ADDENDUM #1

RFP 2024-03: Switch and BOM Replacement

San Marcos Unified School District

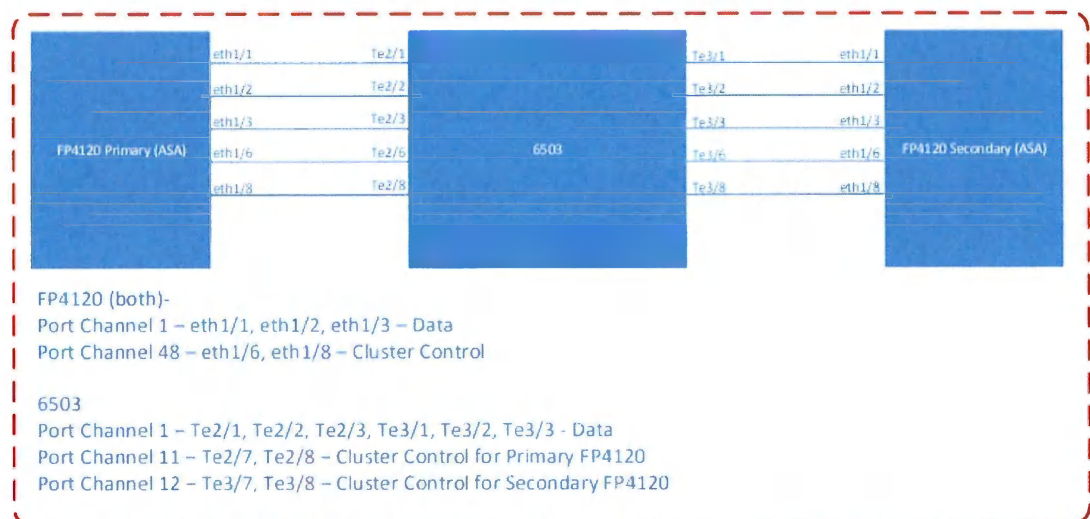
- 1.1.2.3 As we are replacing your existing Cisco 6503 switch with the 9300X, do you have a network diagram showing the current connections that you can provide?

*Answer: We will need this in order to estimate the labor for the installation.
Please see photo. This is a how they are connected. We are no longer running a cluster with the firewalls they are now running HA.*
